**Category:** CDP

**Request ID:** CDP-2406-21

**Project Name:** Fahey South

To: Lisa McNabola  
Sonja Kruesel  
From: Brian Munson  
CC: Chris Ehlers  
Tony Heinrich  
David Fahey  
Grant Emmel  
Date: Friday, October 15, 2021  
Re: Fahey Property Comprehensive Development Plan Staff Comment

**CBU  
LOCATION  
PLAN**

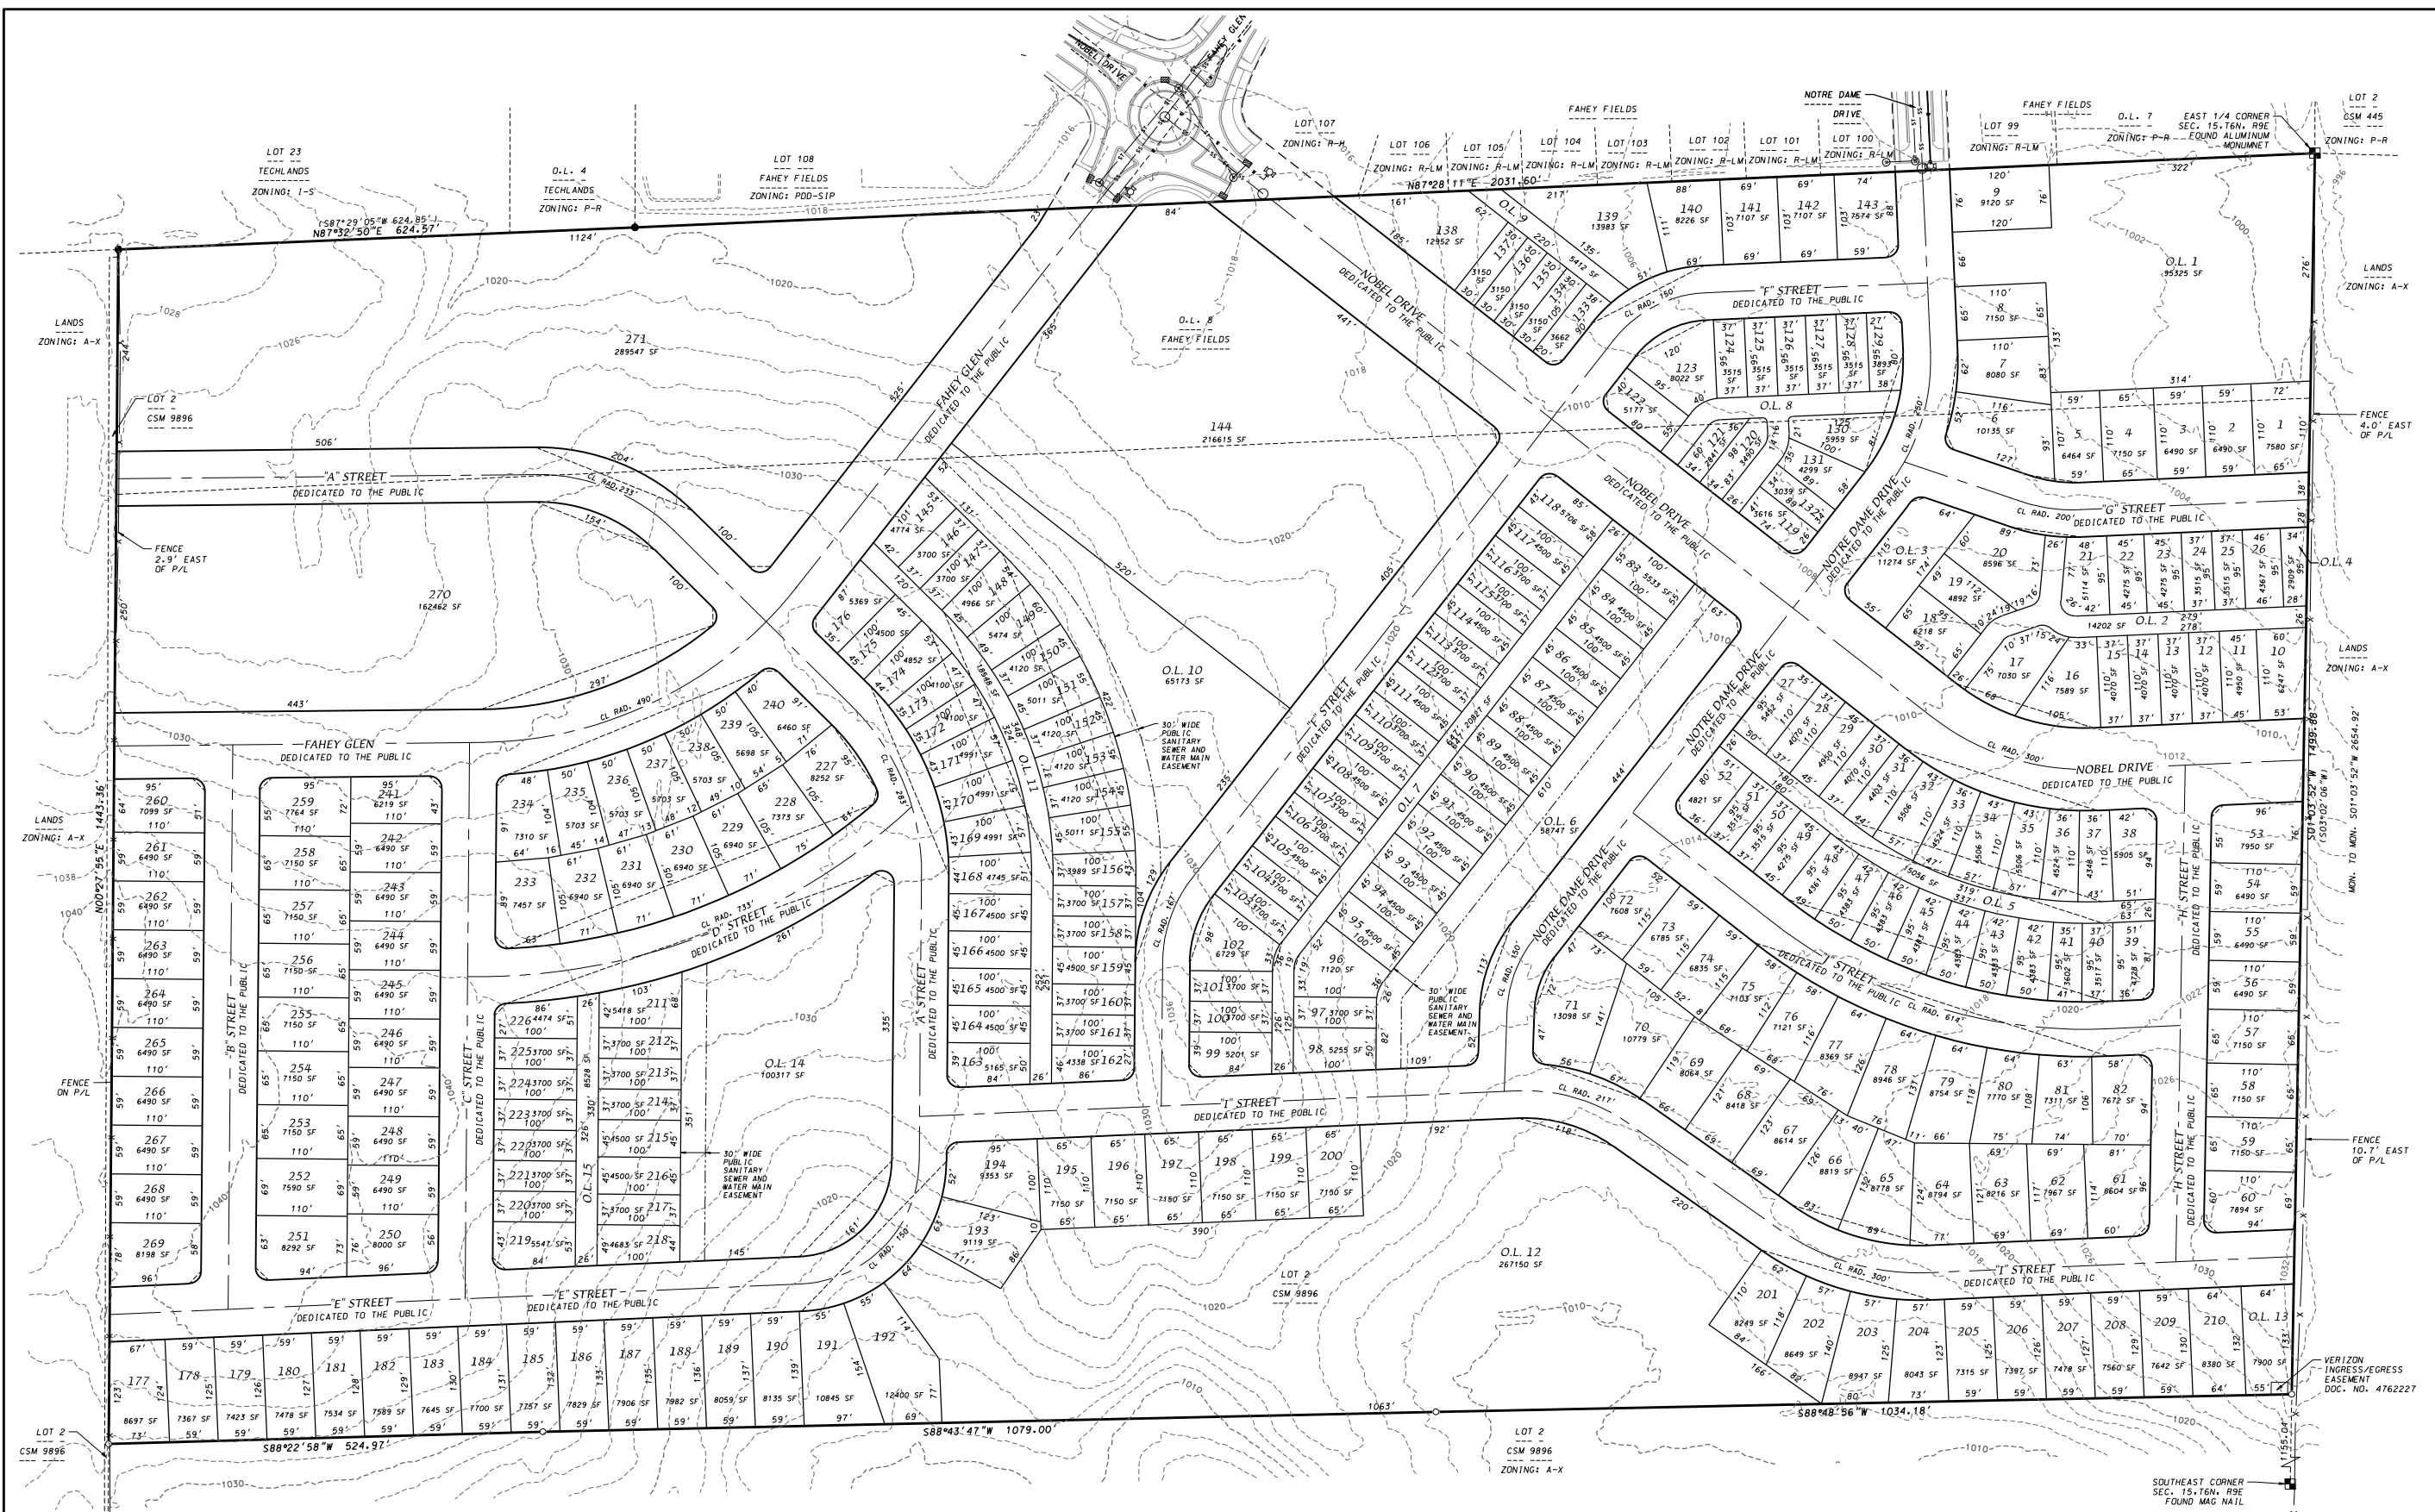
5. Show areas of all easements and ROW on the Plat.  
Ok.
6. Developer needs to provide a designated location for US Postal Service Centralized Mode of Delivery.  
Incorporated into revised submittal document.

**PRELIMINARY SANITARY SEWER SCHEMATIC**  
**DRAFT**

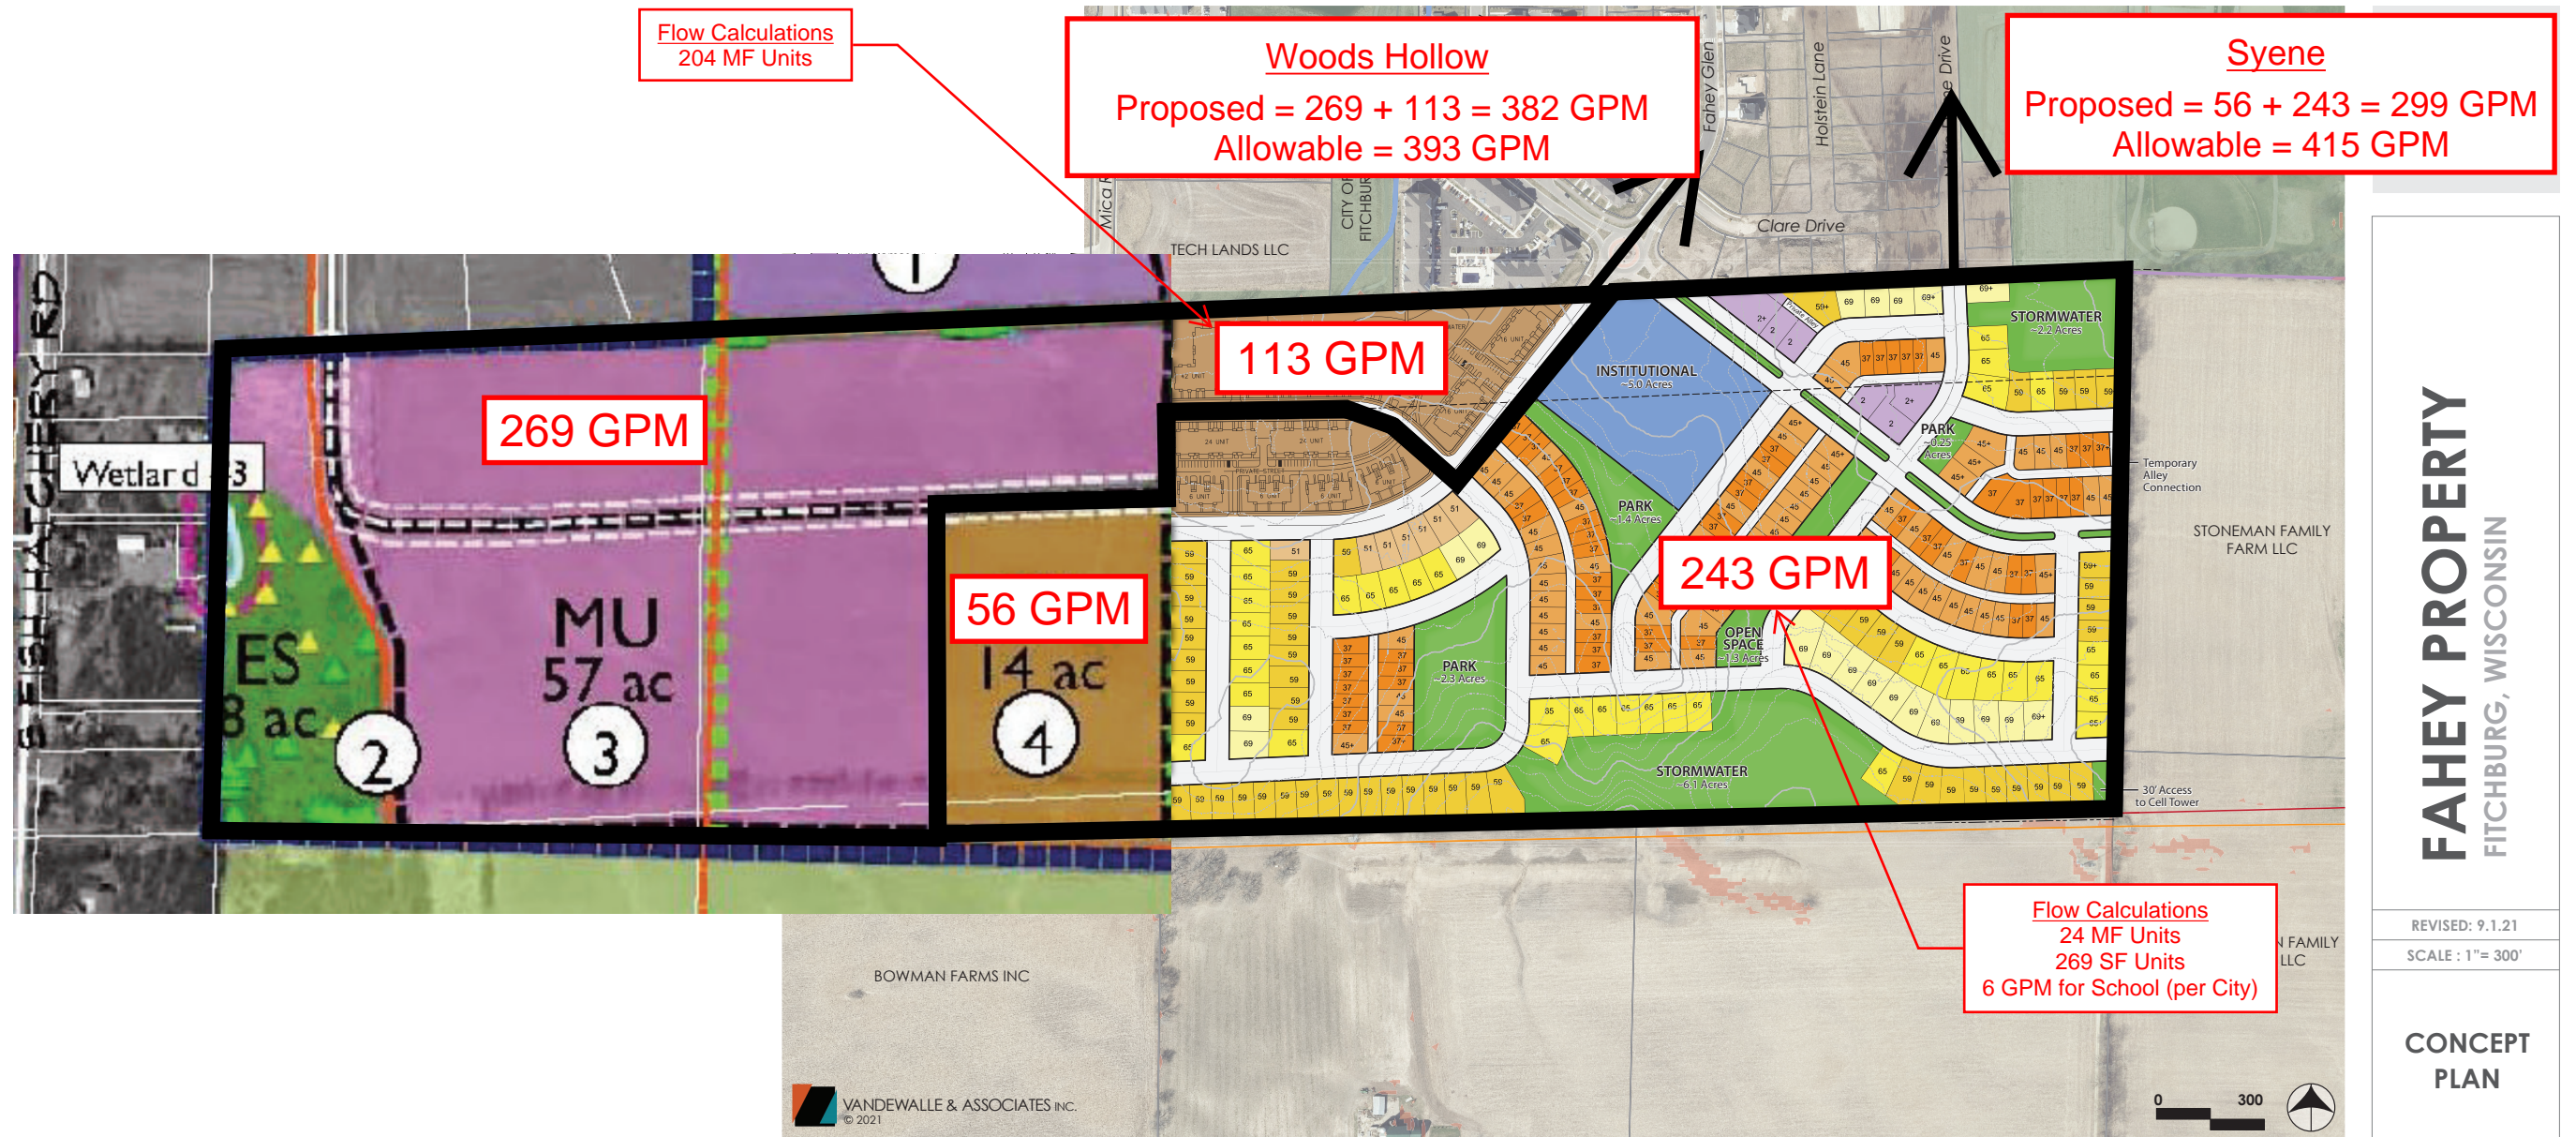
6. Provide complete sanitary sewer layout for review and comment.

Provided

**Conceptual Water Main System Split for Fahey South Option A**

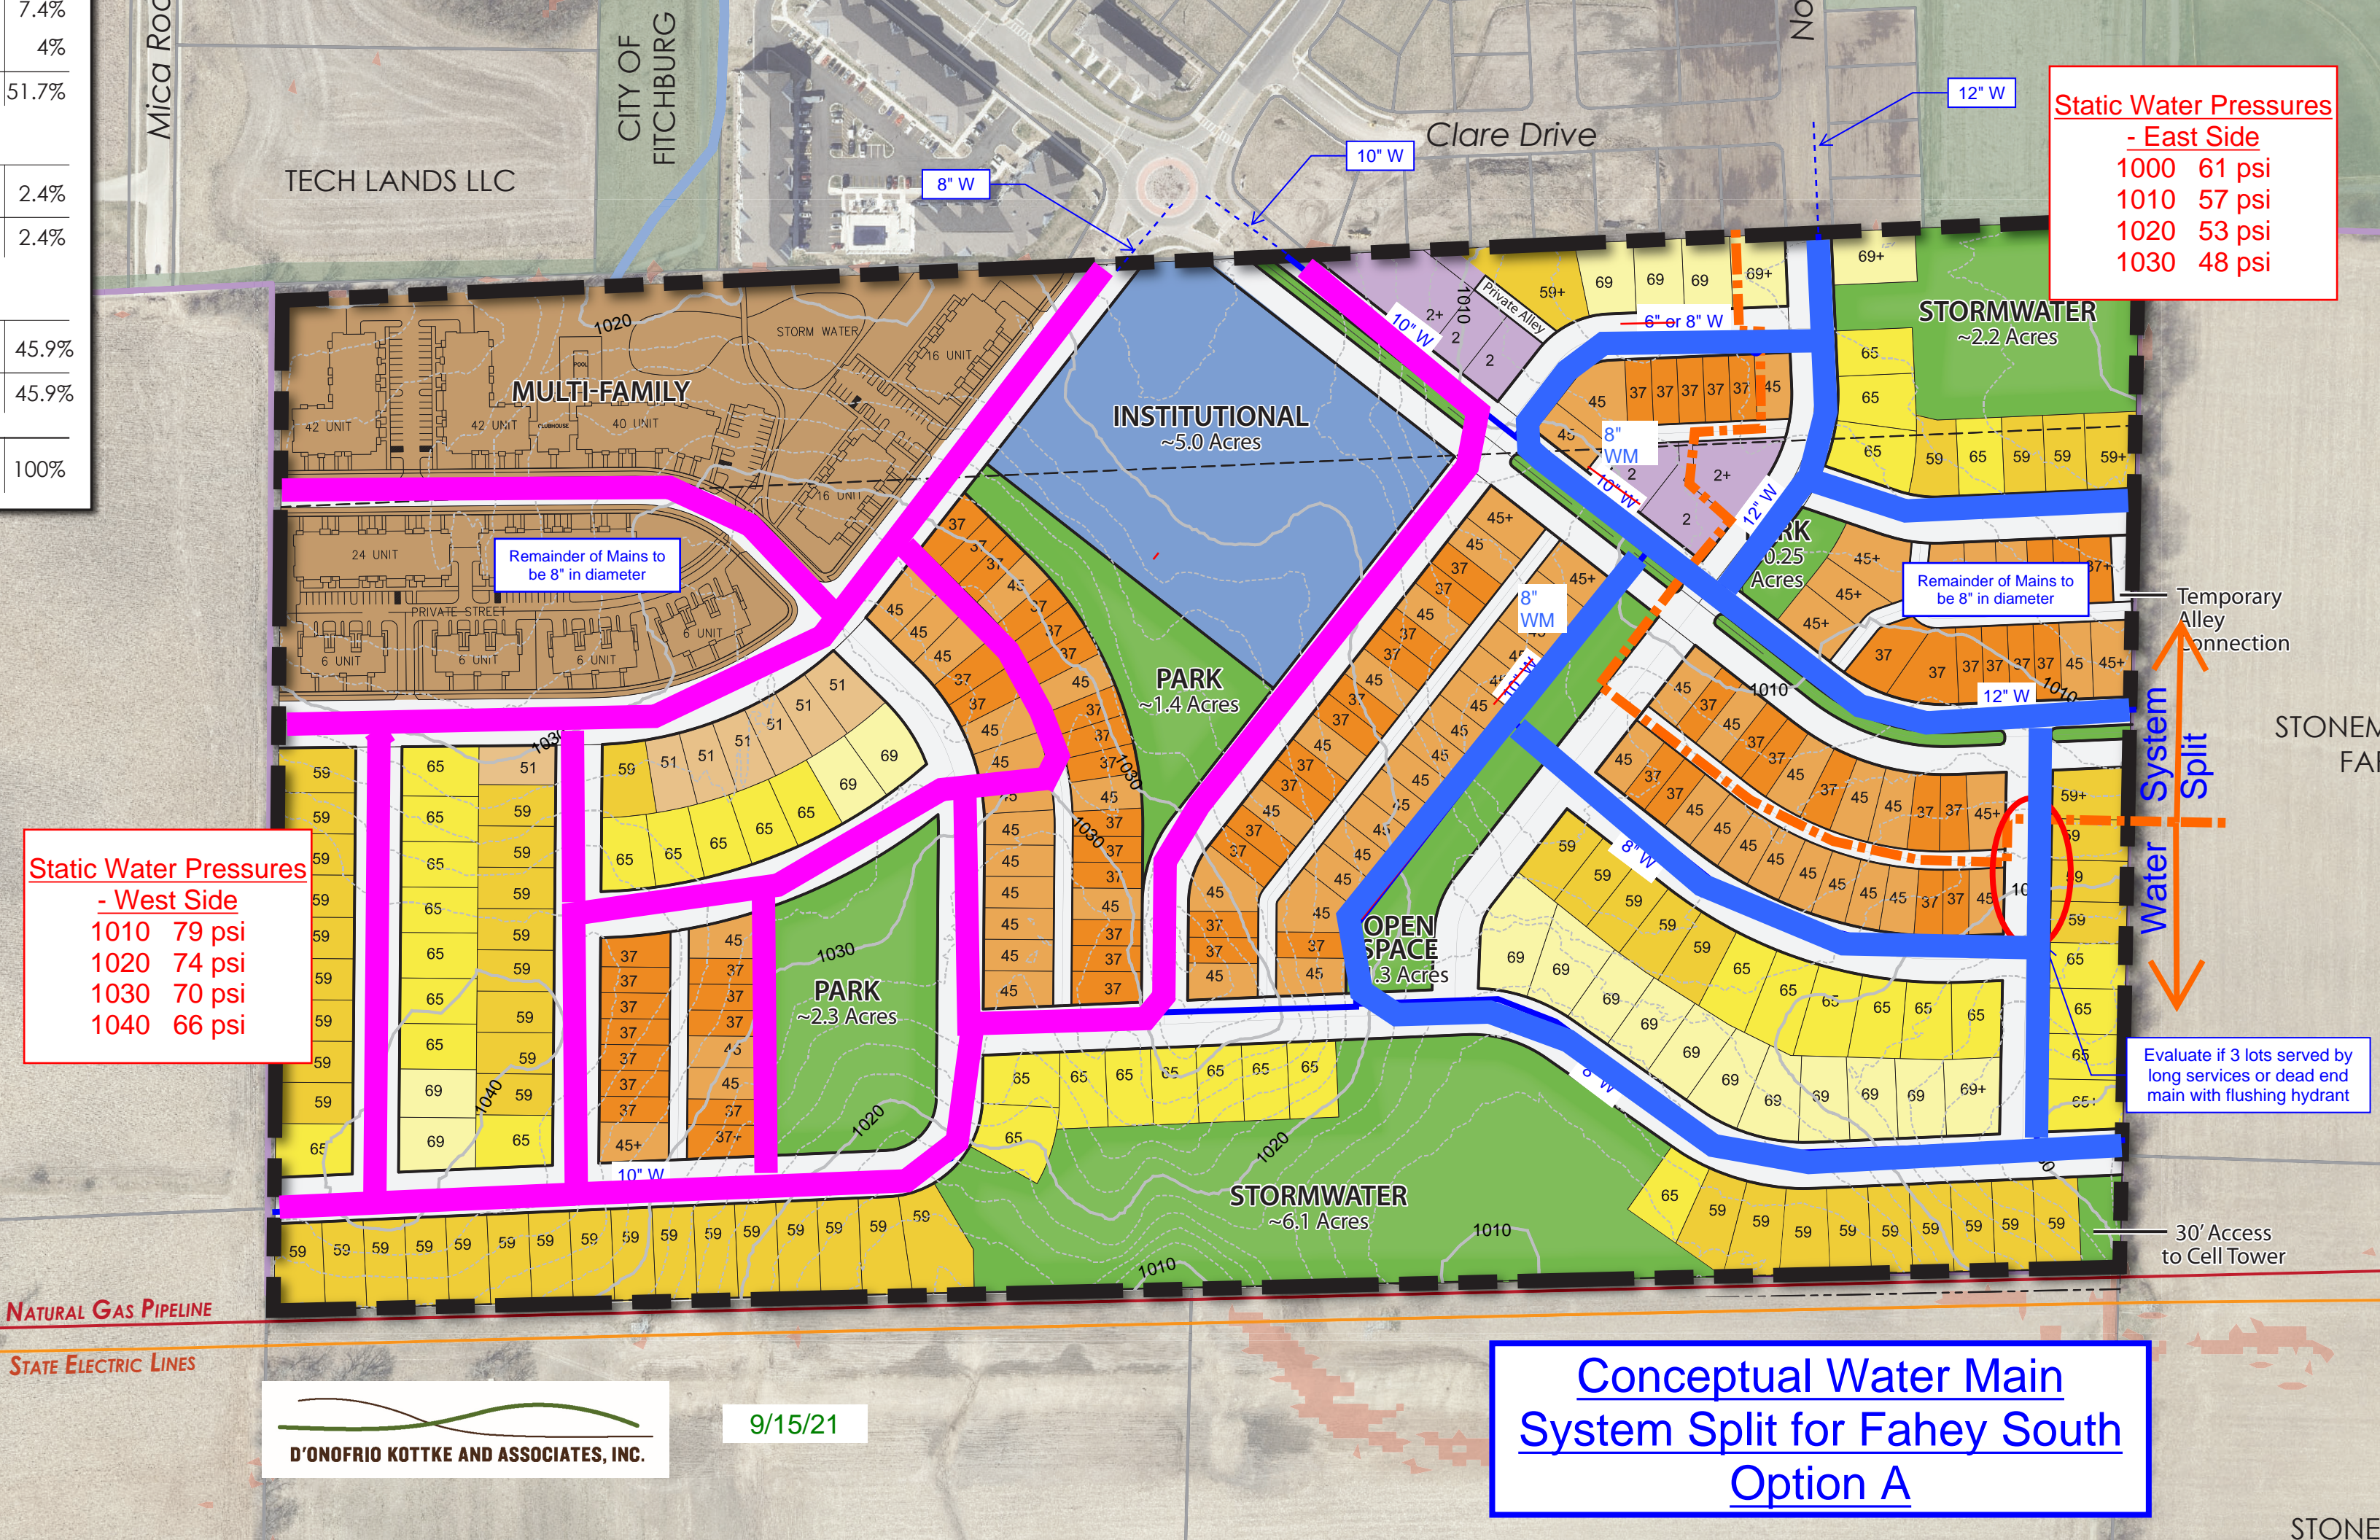
5. Water main layout and zones shall be per the attached Fahey South Water System – Review 1. Update drawings in CDP accordingly.

The layout of the proposed system in the southeast corner is simplified from our previous version but will require approximately 30 sites to have individual boosters. According to the plumbing designers for the homes for Veridian, anything under a static pressure 55 psi at the water meter will require a booster. Although the pressures in the proposed system meet minimum DNR requirements for static pressure, we would like to offer suggestions during the approval process to try to limit the number of boosters required for individual homes.
